A RESOLUTION AUTHORIZING THE ADMINISTRATOR OF THE DEPARTMENT OF PUBLIC WORKS TO AWARD CONTRACT NO. W-12-006-201, ALTON PARK PUMP STATION UPGRADE AND NEW FORCE MAIN TO MAYSE CONSTRUCTION COMPANY, IN THE AMOUNT OF FIVE HUNDRED FORTY-NINE THOUSAND NINE HUNDRED NINETY DOLLARS (\$549,990.00), WITH A CONTINGENCY AMOUNT OF FIFTY THOUSAND DOLLARS (\$50,000.00), FOR AN AMOUNT NOT TO EXCEED FIVE HUNDRED NINETY-NINE THOUSAND NINE HUNDRED NINETY DOLLARS (\$599,990.00).

Subject: Recommendation for Award
Alton Park Pump Station Upgrade and New Force Main
Chattanooga Contract No. W-12-006
CTI Project No. C12008-4

CHANGE ORDER

SCHEDULE II - VALUE ENGINEERED CHANGES

**PROPOSED
REVISED TRENCH
DETAIL IN
33RD ST. & SHOULDER
OF 33RD STREET**
9-19-12
A. Stephens

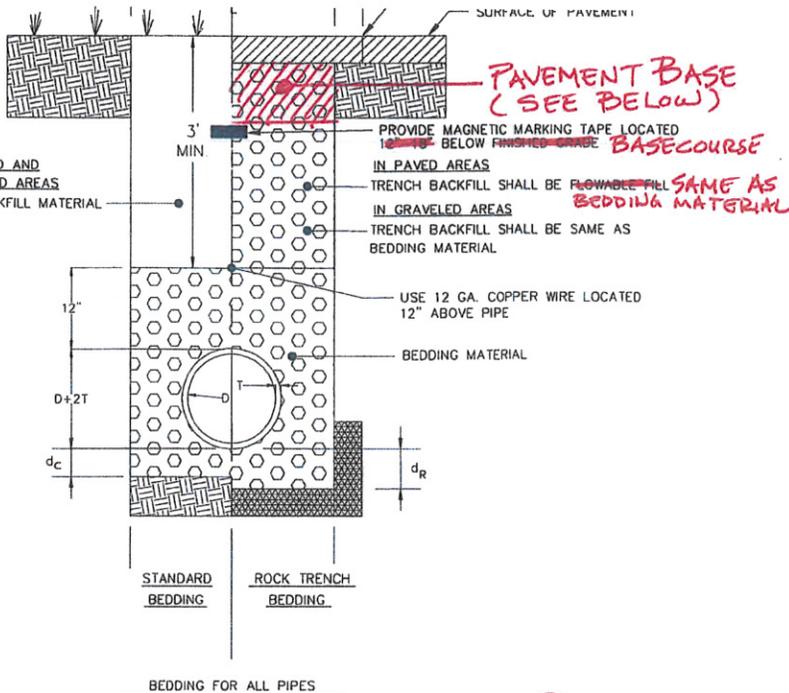
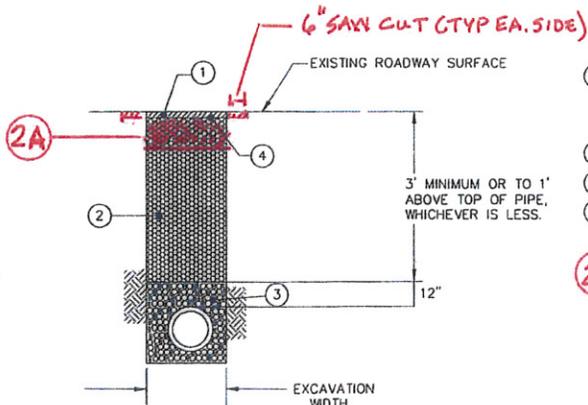
1. ASPHALTIC CONCRETE BINDER COURSE 3-1/2" THICK, GRADING B MODIFIED OR GRADING C, CITY OF CHATTANOOGA SPECIFICATIONS; OR GRADING B, TENNESSEE D.O.T. SPECIFICATIONS.
2. **STONE SAME AS BEDDING MATERIAL** (15")
3. BEDDING MATERIAL - SEE TYPICAL TRENCH AND BEDDING DETAILS.
4. BITUMINOUS MATERIAL FOR PRIME COAT 0.35 GAL./SY WITH CHIPS

2A - BASE
OPTION #1 - Mineral Aggregate (Cement Treated) 9" THICK
ROADWAY QUANTITIES
OPTION #2 - Mineral Aggregate Stone Base (T.D.O.T. 303-01, Type A, Grading "D" T.D.O.T. Spec.) 15" THICKNESS
ROADWAY QUANTITIES
